**COMMENT RESPONSE DOCUMENT (CRD)
TO NOTICE OF PROPOSED AMENDMENT (NPA) 2011-20 (B.III)**

'Authority, Organisation and Operations Requirements for Aerodromes'

(B.III) CRD to NPA 2011-20 (B.III) – CS-ADR Book 1 and 2'

IV. CRD table of comments, responses and resulting text

Figure H-1. Inner horizontal surface where the runway is code 4

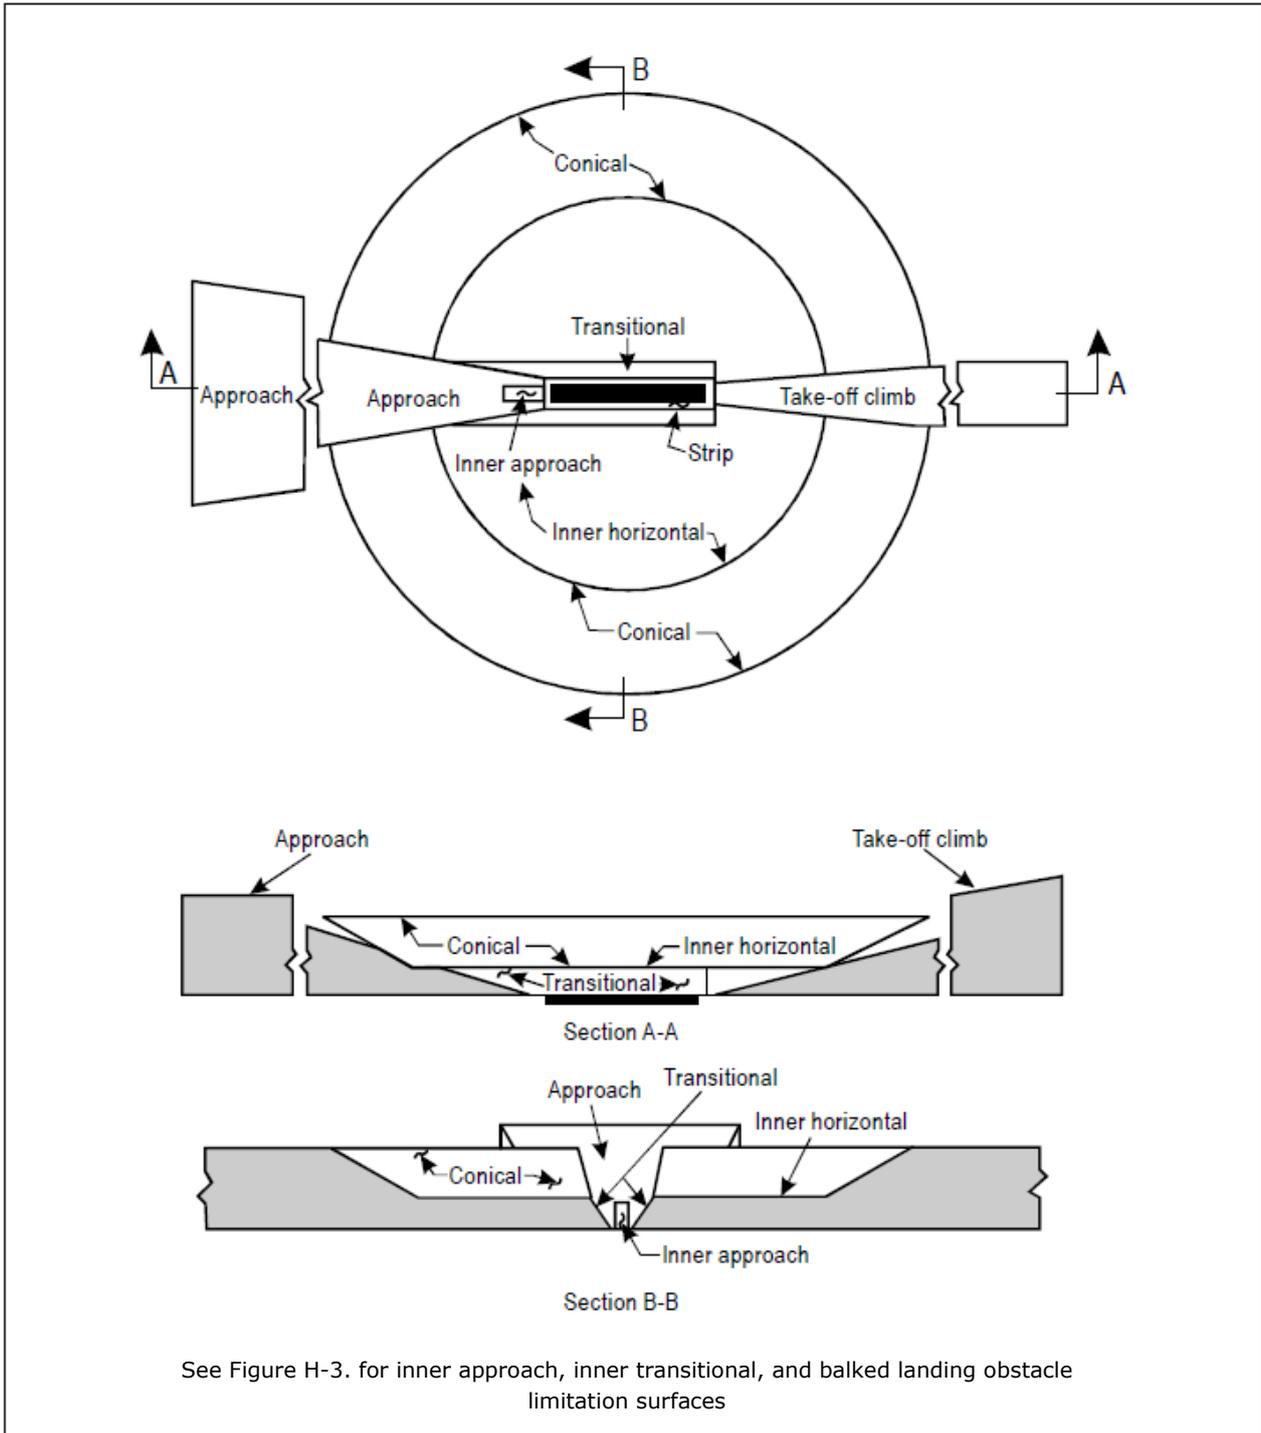
Finally, figure H-1 and figure H-2 are meant to be in guidance material because they are only an example of a possible design of the OLS, particularly concerning the design of the inner horizontal surface which is not, as said truly in the GM associated, necessary circular. The option of designing the OLS from the transitional surface support line (see CS-ADR-DSN.H.430 paragraphs (c)(3) and (d)(3)) is not taken into account either by these examples.

As the center of circular arcs has changed (the intersection of the extended RWY centre line with the end of the RWY strip), the Figure H-1 has to be updated.

Figure H-1: It is appropriate to transfer this provision into GM.

Figure H-1: It is appropriate to transfer this provision into GM.

Thus DGAC proposes to move parts of this CS to GM and proposes to move figure H-1 and figure H-2 to GM as "figure GM-H-1" and "Figure GM-H-2" respectively. Existing figure GM-H-1 thus becomes "Figure GM-H-3".

(c) Characteristics: The outer limits of the inner horizontal surface are defined by circular arcs centred on the intersection of the extended RWY centre line with the end of the RWY strip joined tangentially by straight lines. ~~(Figure H-1.)~~

~~**Figure H-1 Inner horizontal surface where the runway is code 4**~~

Figure H-2. Obstacle limitation surfaces

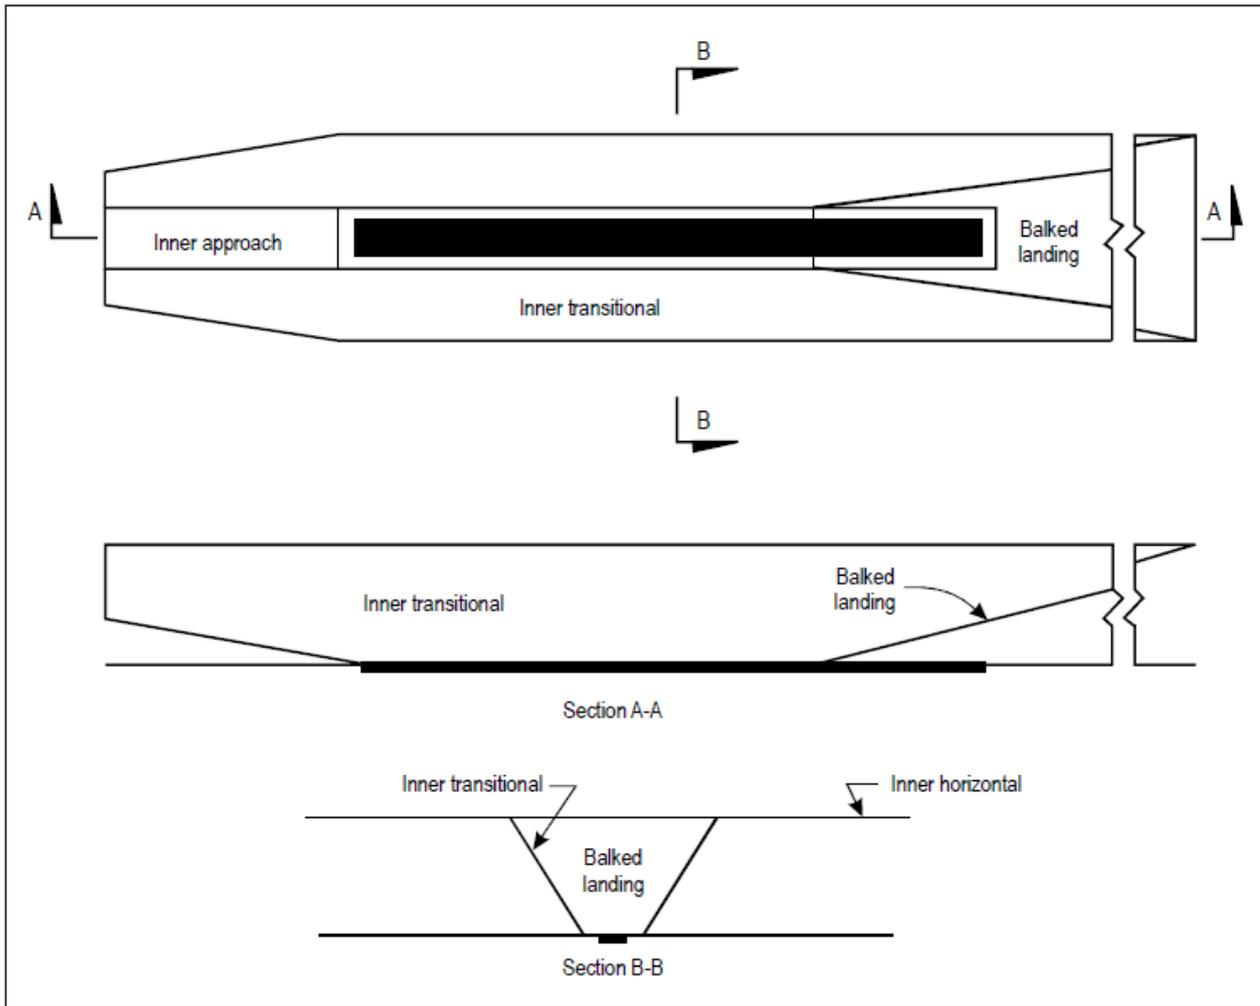
Change provision to: [...] where the code number is 4 or the aerodrome reference point (ARP) where the code number is 3 or less. All established OLS for runways with code number 3 or less in Switzerland are defined by circular arcs centred on the ARP, as showed in Figure H-2 and described in the GM-ADR-DSN.H.420 (c) in this NPA.

Figure H-2: It is appropriate to transfer this provision into GM.

~~**Figure H-2 Obstacle limitation surfaces**~~
